**STAFF REPORT
FOR THE PLANNING COMMISSION**

FILE NUMBER: SUB-13-02/VAR-13-05/VAR-13-06
HEARING DATE: October 2, 2013

REQUEST: 11-lot subdivision with Class II Variance for two lots with depth more than 2.5 times their width

STAFF REPORT PREPARED BY: Tom Soppe, Associate Planner

SHEET TITLE
TREE PLAN
 SHEET NUMBER
C1.2

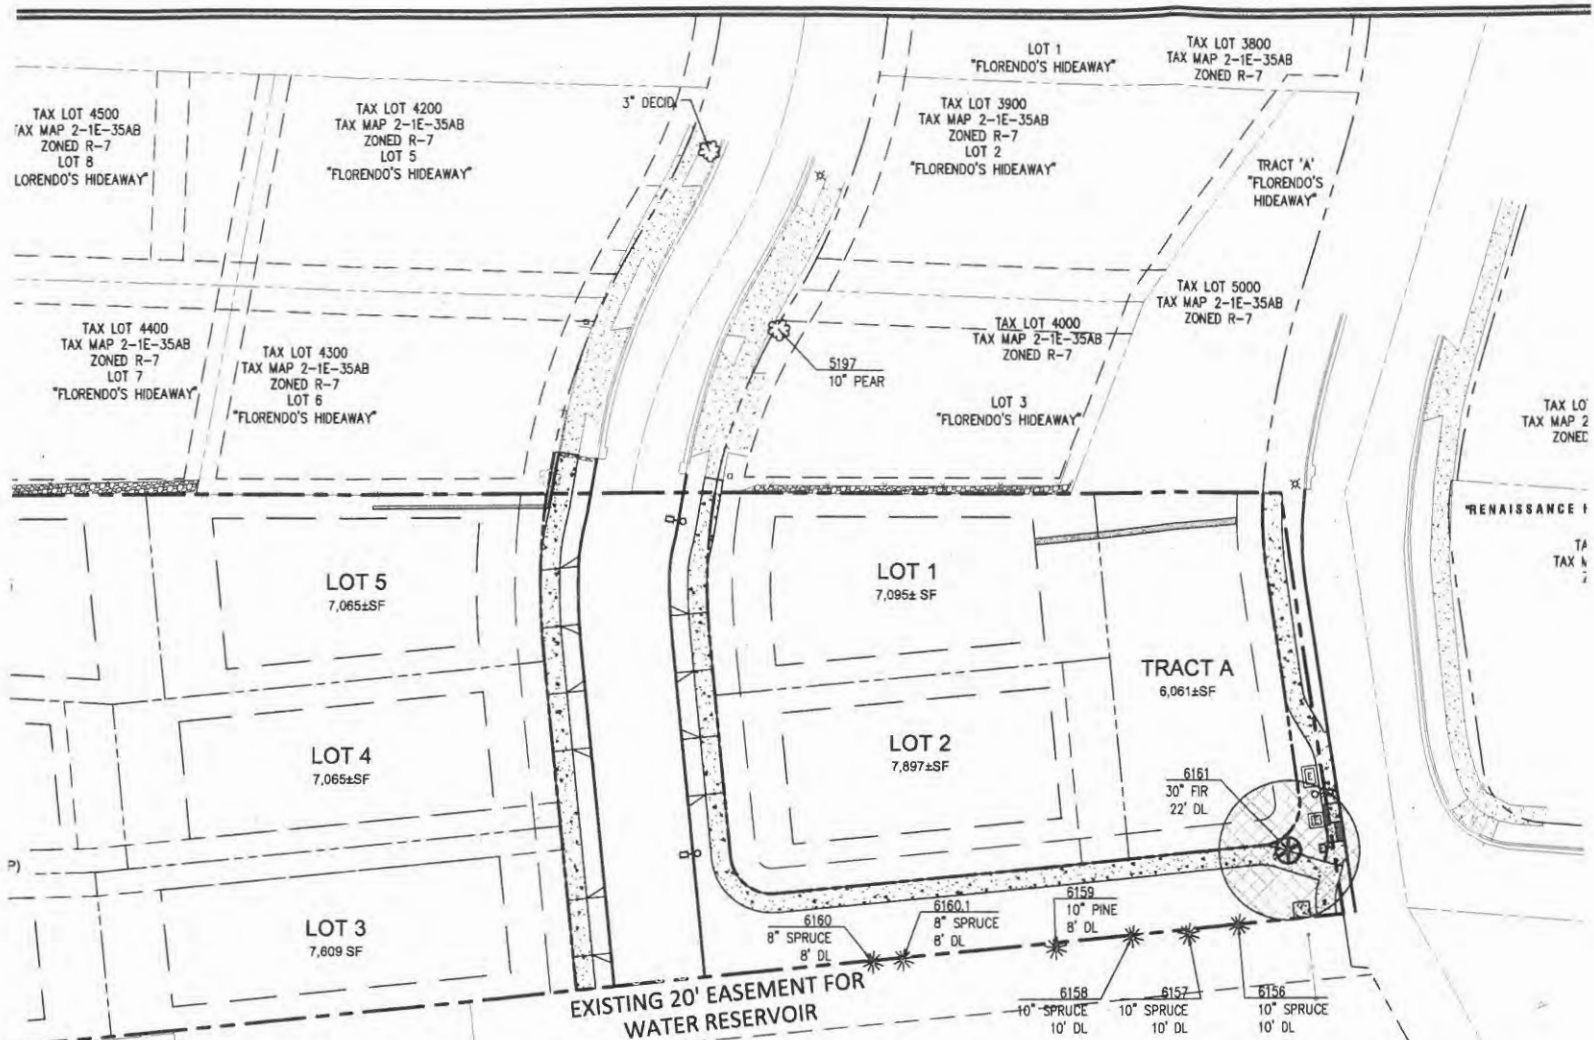
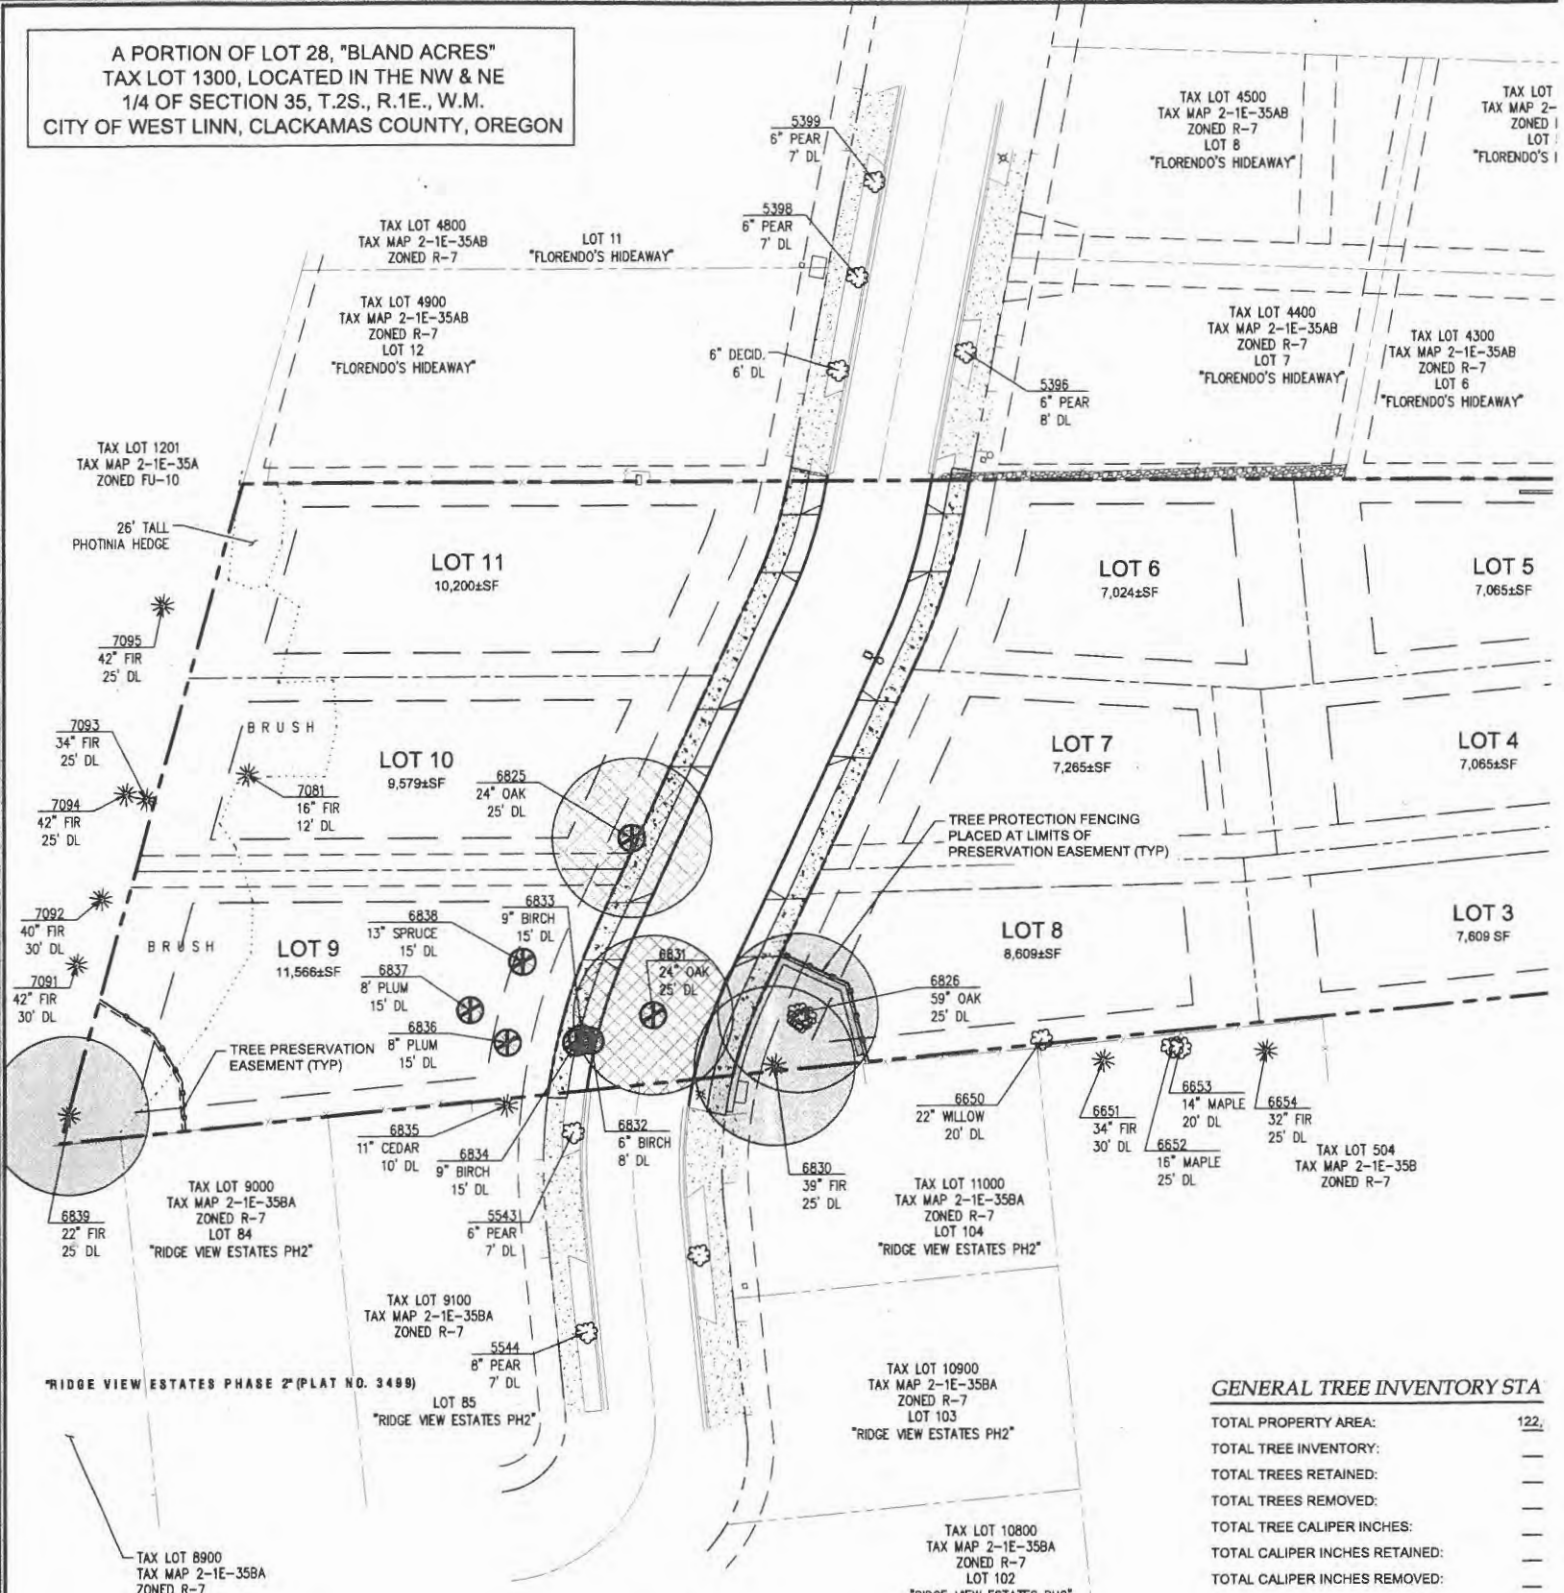
Staff Response 42: There are no heritage trees on site. The City Arborist agrees with the applicant’s Tree Plan, Sheet 1.2, on Page 59 of Exhibit PC-5 as to which trees are significant. All significant trees on site will either be preserved or will be removed due to the necessary trajectory of Crestview Drive to connect the two existing stubs. Removing of significant trees due to necessary street construction is permitted with mitigation per 55.100(B) (2). Three significant trees are proposed to be removed for street installation: two 24-inch oaks and a 30-inch fir. This is a total of 78 inches. Recommended Condition of Approval 3A requires one-to-one mitigation for the 78 inches of significant trees to be removed. Recommended Condition of Approval 3B also requires that for the tree conservation easements proposed on lots 8 and 9 (and an addition conservation easement for new trees referred to in Condition of Approval 3A), the applicant use the City’s standard language for such easements. Staff determines that the criterion is met upon the inclusion of Condition of Approval 3.

- B) The applicant shall provide a five-foot-wide utility easement along the eastern boundary of Lot 11.
3. Trees.
 - A) The three significant trees to be removed for street construction shall be mitigated for on an inch-to-inch basis. Therefore 78 inches of new trees total shall be planted on site (in addition to proposed street trees). This shall include the planting of evergreen trees beside the retaining wall adjacent to the stormwater pond where possible and planting of appropriate trees elsewhere in or beside Tract A. If all of the trees cannot be appropriately accommodated of site given their size at maturity, they may be planted on City-owned land as approved by the Parks and Recreation Department. Any trees planted on lots 1 or 2 to screen the wall on Tract A shall be placed in a conservation easement using the tree conservation easement referred to in Condition of Approval 3B. If trees are planted that fulfill the 78-inch mitigation requirements and these do not fully screen the wall, additional trees shall be planted so the wall is fully screened.

SHEET TITLE
 SUBDIVISION PLAT
 SHEET NUMBER
C2.0

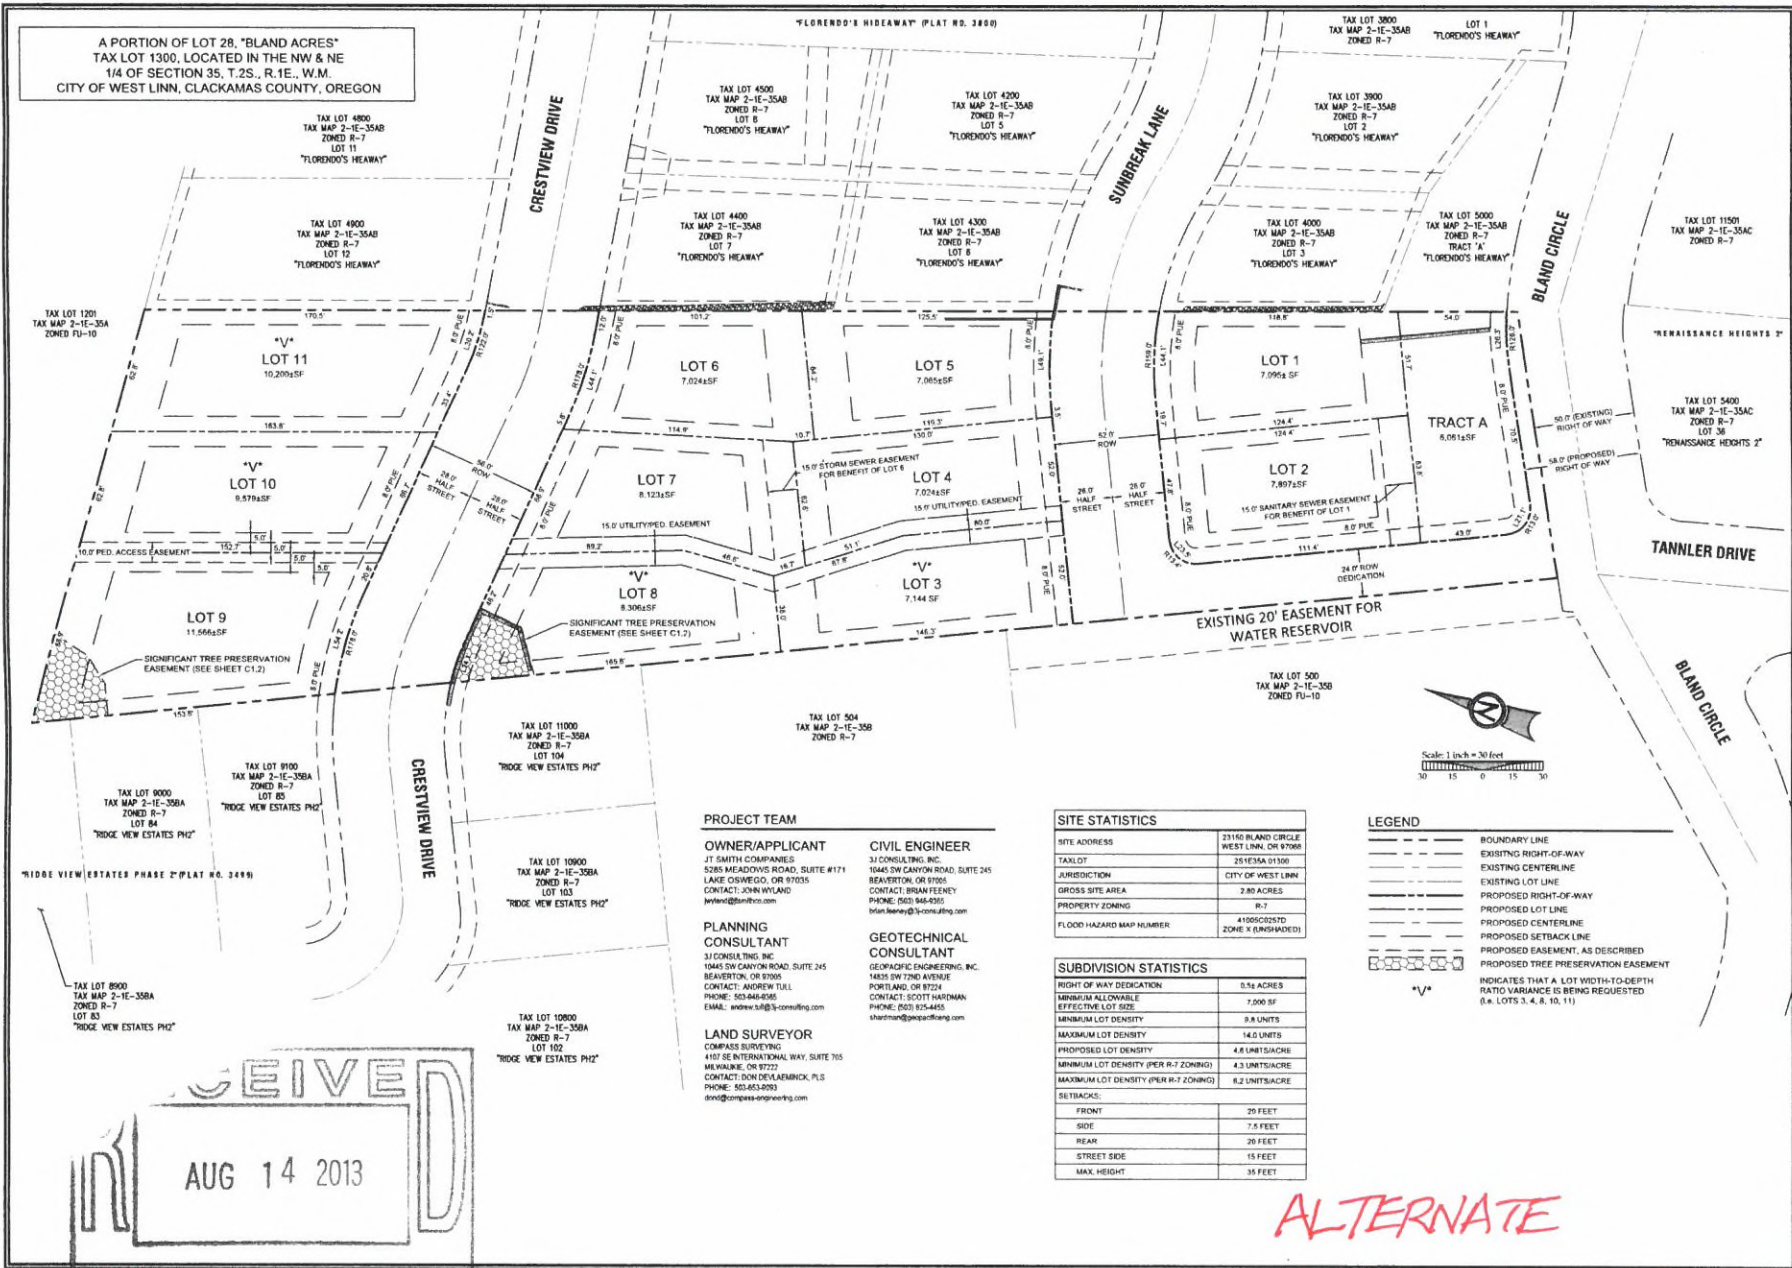
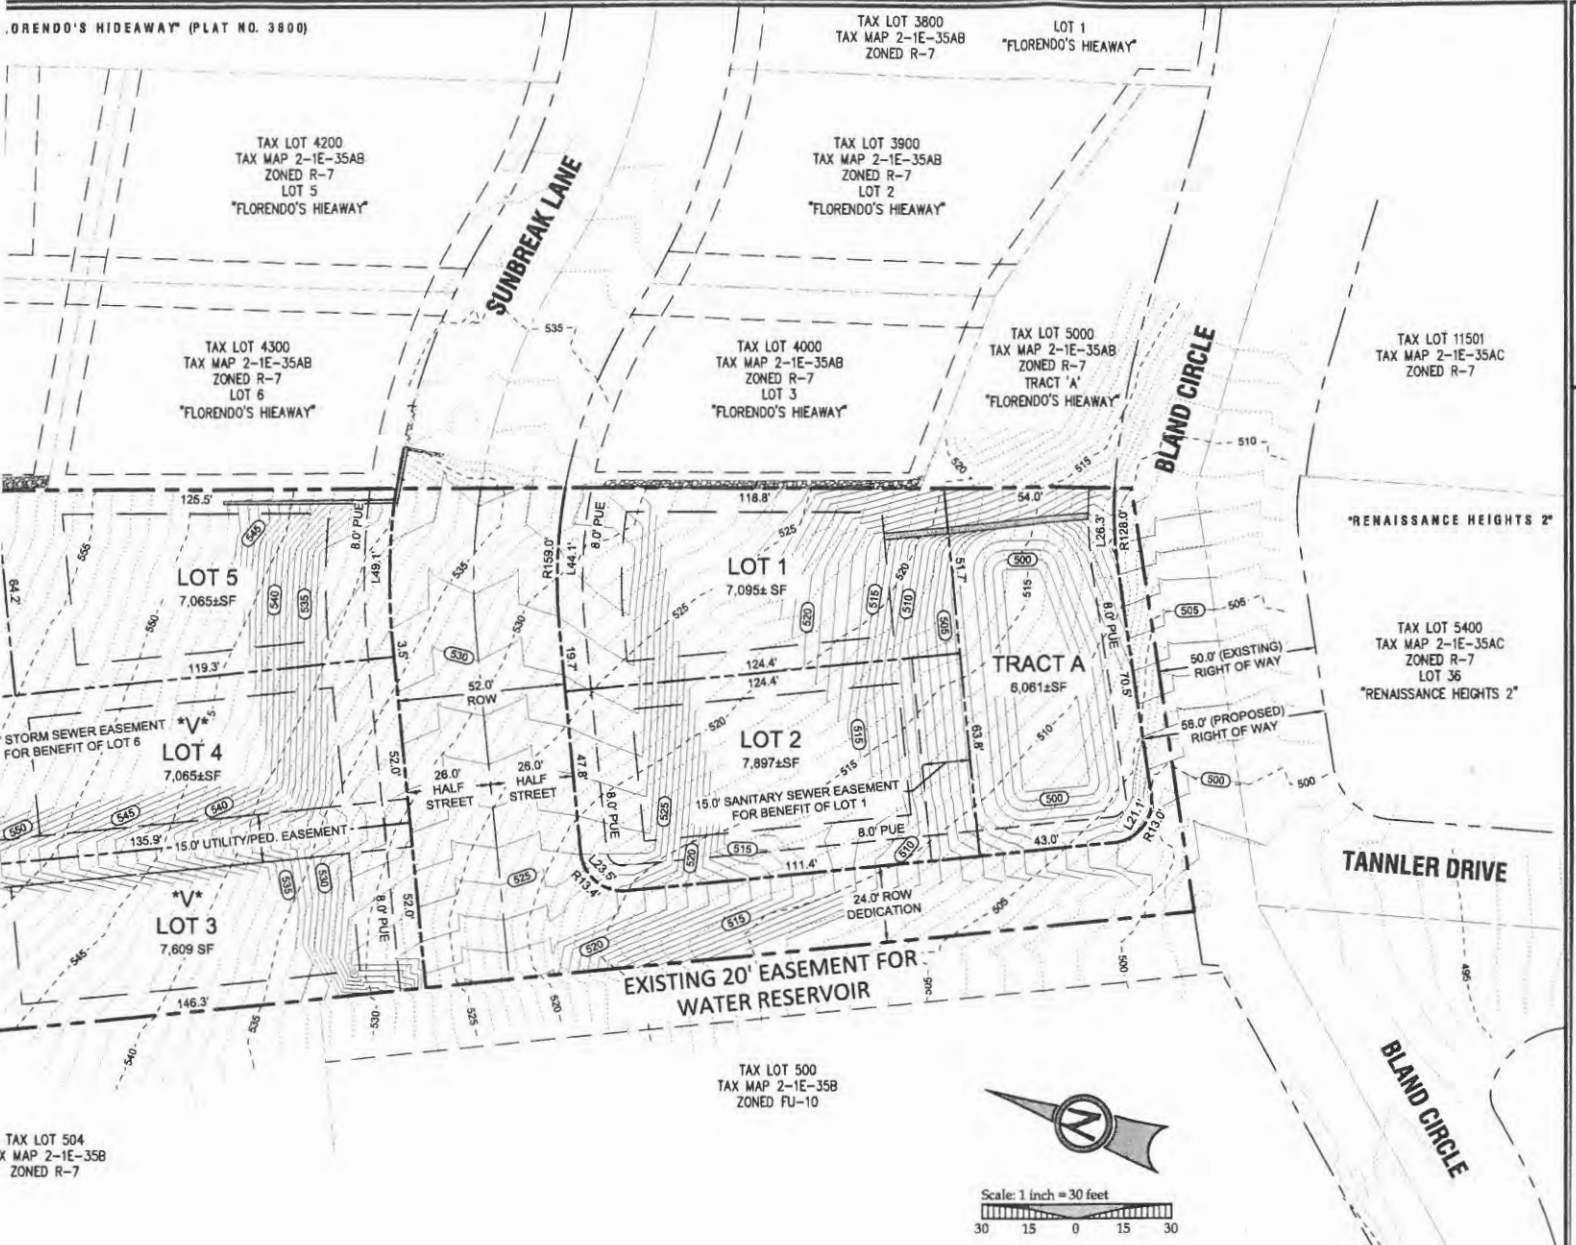
Staff Response 2: As shown on the Tentative Subdivision Plat, Sheet C2.0 (revised 9-11-13), on Page 61 of Exhibit PC-5, all proposed lots are at least 7,000 square feet in size. Staff finds that the criterion is met.

Staff Response 3: As shown on the Tentative Subdivision Plat, Sheet C2.0(revised 9-11-13), on Page 61 of Exhibit PC-5, all proposed lots have a front lot line that is greater than 35 feet in length. Staff finds that the criterion is met.

Staff Response 4: As shown on the Tentative Subdivision Plat, Sheet C2.0 (revised 9-11-13), on Page 61 of Exhibit PC-5, all proposed lots have a minimum average width of at least 50 feet. Staff finds that the criterion is met.

1. Site Plan. With the exception of modifications required by these conditions, the project shall conform to the Subdivision Plat, Sheet C2.0, dated September 11, 2013

3J JOB #	11113
LAND USE #	
TAX LOT #	2512540136
DESIGNED BY	C.F.T.
CHECKED BY	J.B.
SHEET TITLE	BLAND CIRC. PL.
SHEET NUMBER	
C2.7

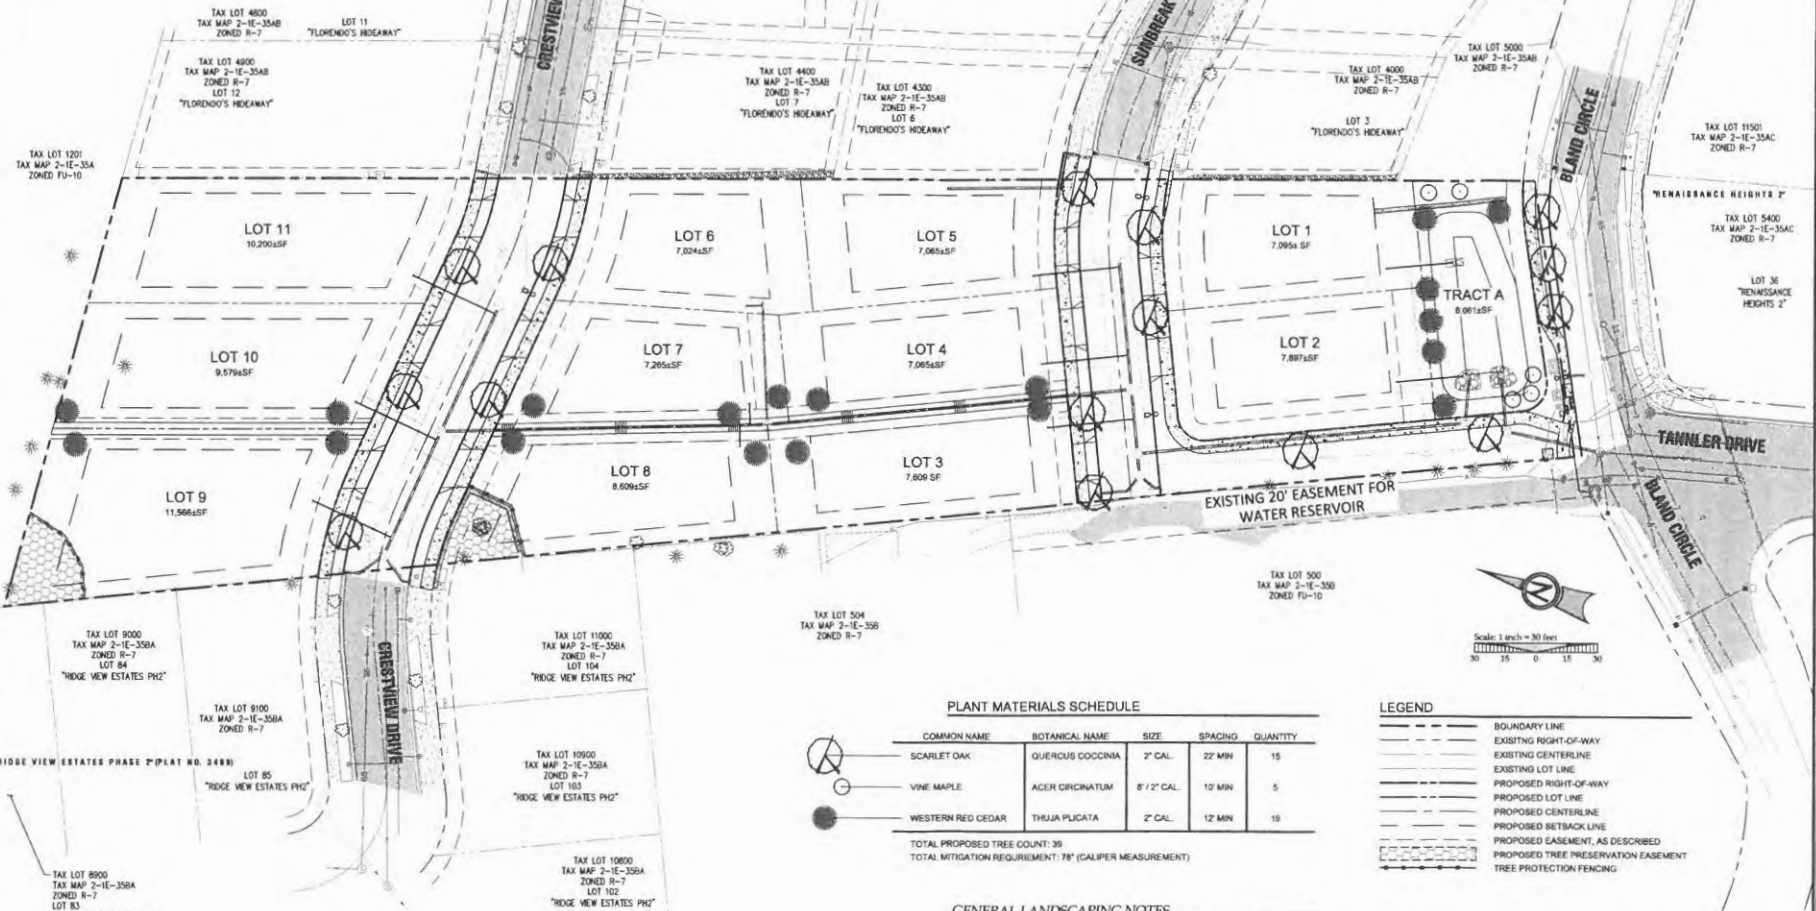
Subsection 85.200(A) (16) provides for sidewalk installation. As future installation of the sidewalk, as shown on Sheet C2.7, interferes with the location of existing utility boxes, recommended Condition of Approval 9 requires that these boxes and any future utility boxes be relocated to an area outside the right-of-way and proposed sidewalk and ramp areas.

8. Street and Trail Improvements.
 - A) The applicant shall install sidewalk, curb, and ADA ramps for pedestrian connection between Sunbreak Lane and Bland Circle as shown on sheet C2.7.

- B) Fee-in-Lieu for Pavement Improvement. The applicant shall pay a fee-in-lieu for the eventual pavement improvement of the dedicated street right of way between Sunbreak Lane and Bland Circle at the west edge of the site as shown on Sheet C2.7.
